Case Number: 2011-031138R

ADDRESS 3704 Bonnell Drive

Residential Design and Compatibility Commission

We appeal the August 26, 2011 decision of Greg Guernsey of the Planning and Development Review Department to "approve for permit" the building plans for 3704 Bonnell Drive, attached as Exhibit Ex1; alleging error was made in the decision by an administrative official.

THIS HABITABLE PORTION OF THE ATTIC IS UNDER 7' HIGH, AND IS 398 SF IN SIZE.

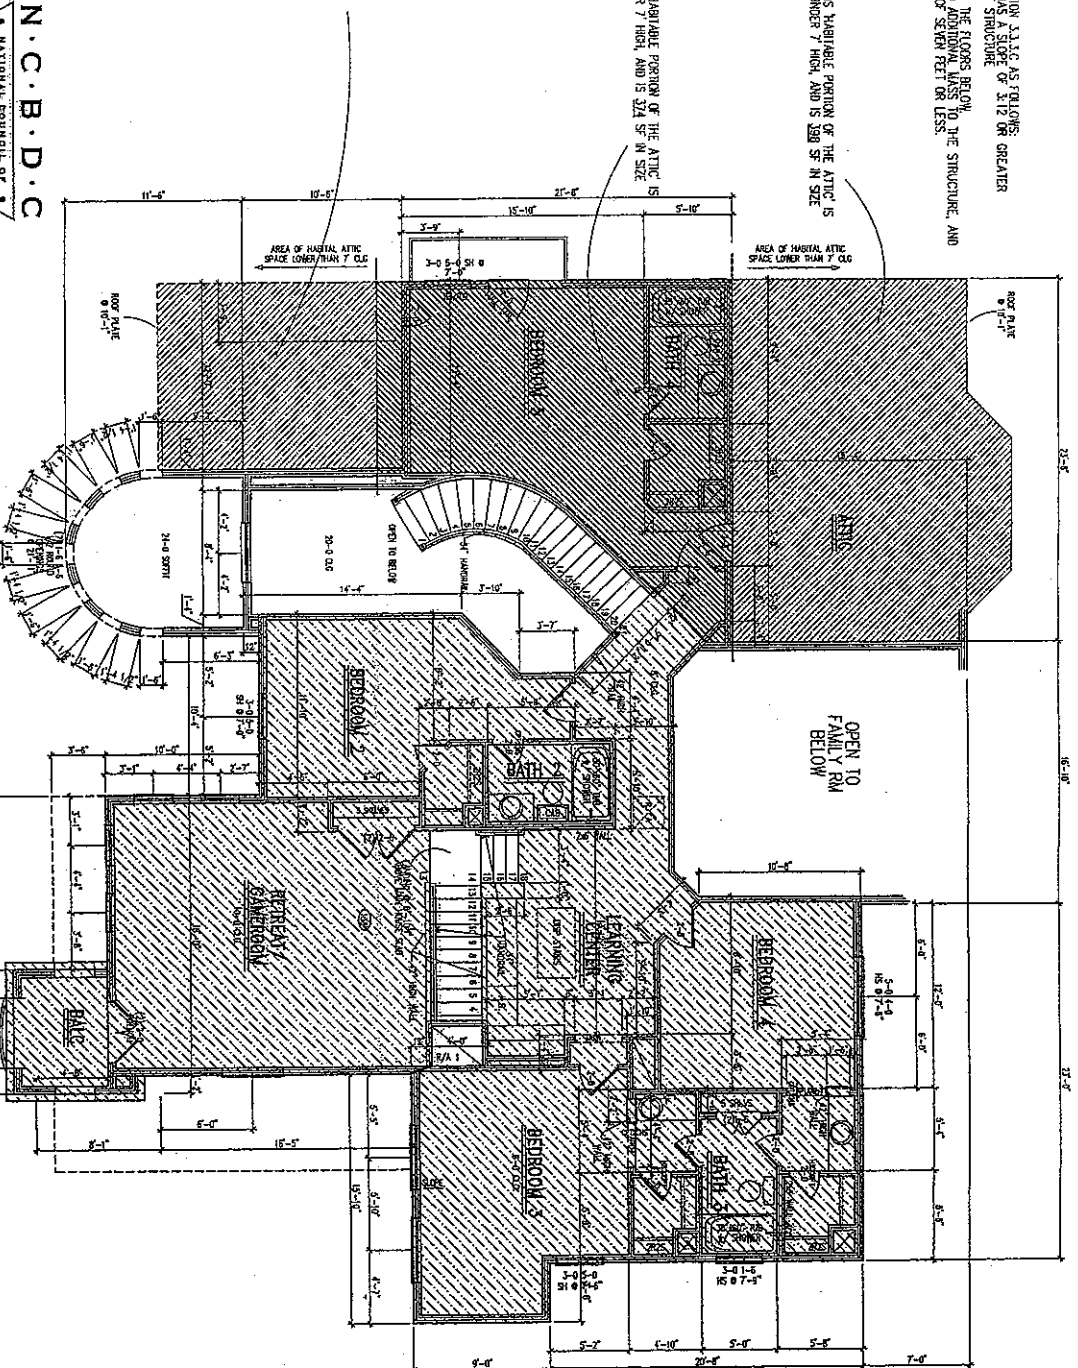
We feel the correct interpretation is: the area identified as “habitable attic space” in the application does not qualify for a habitable attic exemption under Subsection 3.3.3.C, because we believe that bedroom 5 and bathroom 4 are part of the second floor, not part of an attic, and therefore not eligible for the habitable attic exemption. The applicant’s designating bedroom 5 and bathroom 4 as the only finished portion of the second floor that is habitable attic space has no basis other than his interest in finding floor space that might be exempted from the F.A.R calculation. That there are interior walls separating these two rooms from the rest of the finished part of the second floor is not a basis for excluding other finished portions of the second floor, continuous with these rooms, from being habitable attic space, for an interior wall can exist within an attic. Roof coverage is also not a basis for excluding other finished portions of the second floor continuous with bedroom 5 and bathroom 4 from being habitable attic space, for a section of roof that covers a portion of these two rooms also covers portions of other finished rooms on the second floor. To be able to determine whether floor space is habitable attic space exempt from the F.A.R. calculation, one has to be able to determine what the boundaries of the alleged habitable attic space are for the purpose of doing the calculation, and there is no way of determining these boundaries in the applicant’s plan.

NORTH
3688-B
INT-2
LUNDY
BOL. AUSTIN

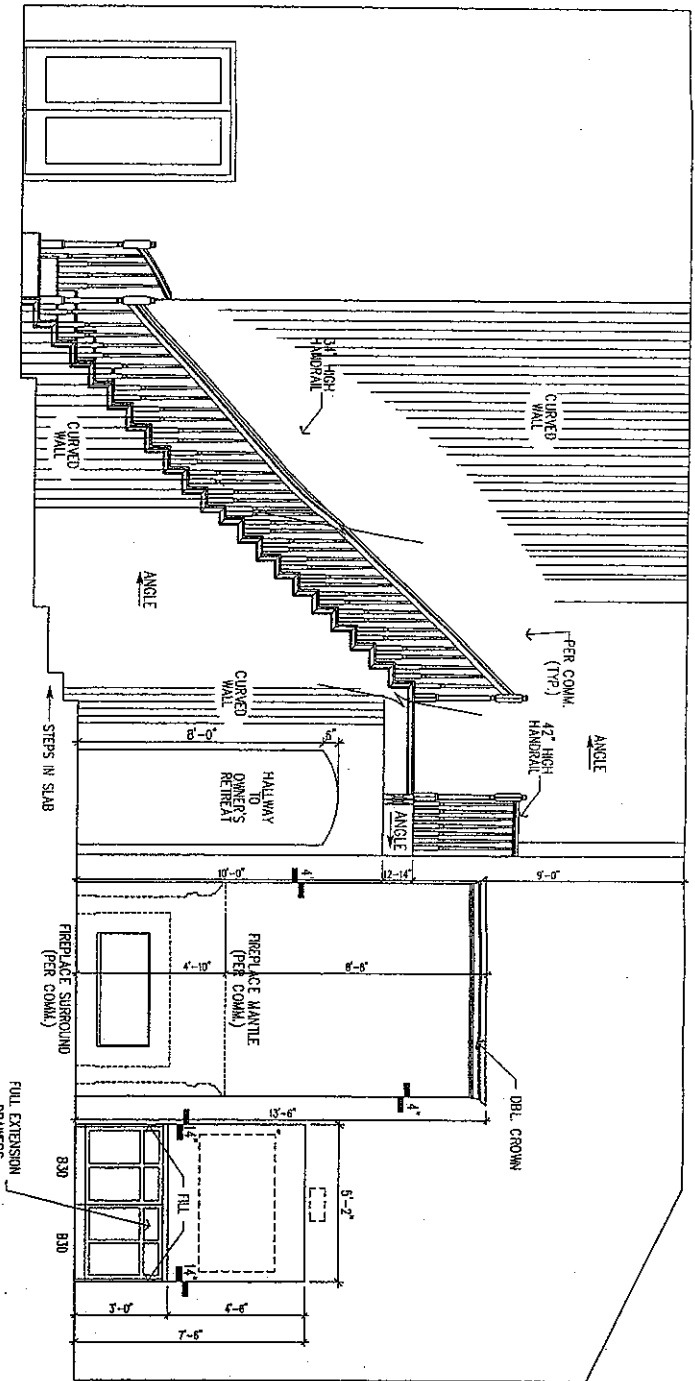
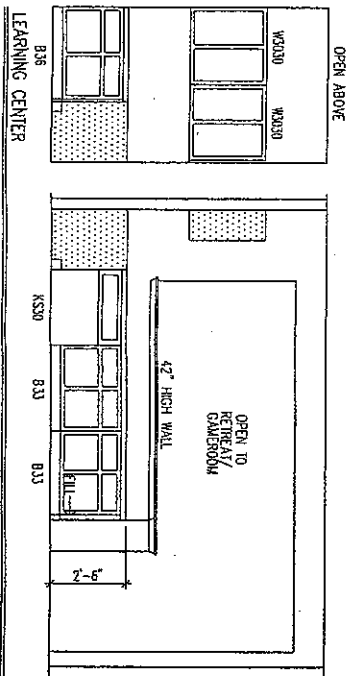
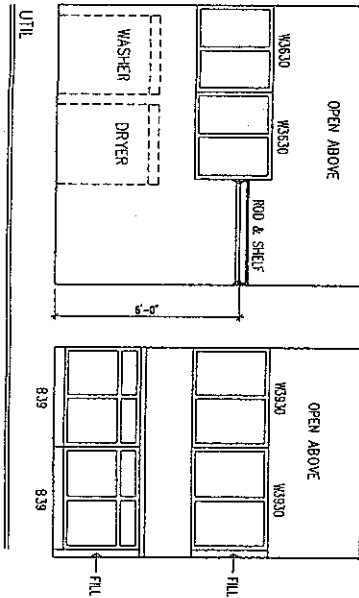
The plans submitted by the applicant show that the family room and foyer have ceiling heights between 20 and 22 feet (section of first floor layout showing this attached as Exhibit Ex5). Based on the dimensions shown on the plans, these areas have a combined floor area of at least 450 square feet. Properly double-counting these floor areas would increase the GFA from 4,537 to at least 4,987 square feet. This means the FAR would increase from 38.83% to at least 42.69% ($4,987 / 11,683$), which exceeds 40% - the maximum amount of development permitted under Section 2.1 of the McMansion Ordinance.

EXHIBIT
EX1

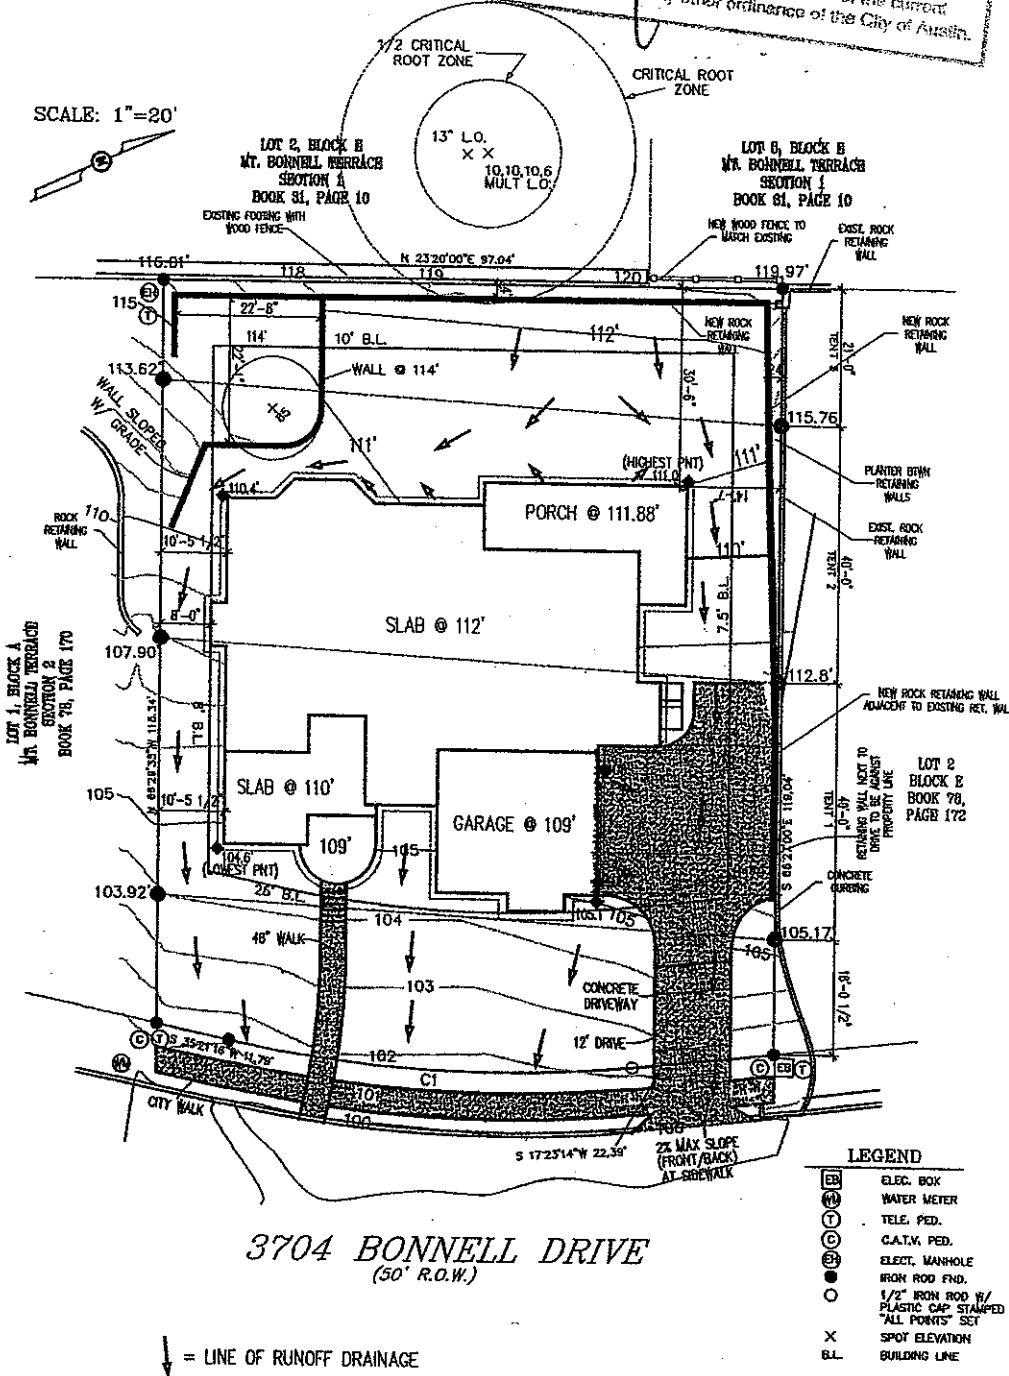
- B. **With regard to plans to build a fence on neighboring property:** The Site Plan – Final Grade, attached as Exhibit Ex1, shows a structure labeled “New Wood Fence to Match Existing” *behind* the back property line – constructed entirely on Lot 3, Block E, Mt. Bonnell Terrace Section 1 (street address 3703 Mount Bonnell Road). This lot belongs to Mr. Tom Shelton, who told Jim Einhaus of David Weekley Homes, in writing more than two months ago, that the applicant could not build a fence on Mr. Shelton’s property. Mr. Einhaus replied that the plan would be corrected but it is still in error. This proposed new fence should not be relied on by the CoA as proof that the applicant is building any fence that may be required in this spot. In addition, if workers view these plans and mistakenly start to clear the area for the fence they will destroy several Texas Mountain Laurels that Mr. Shelton has planted in that area. These plans need to be corrected.
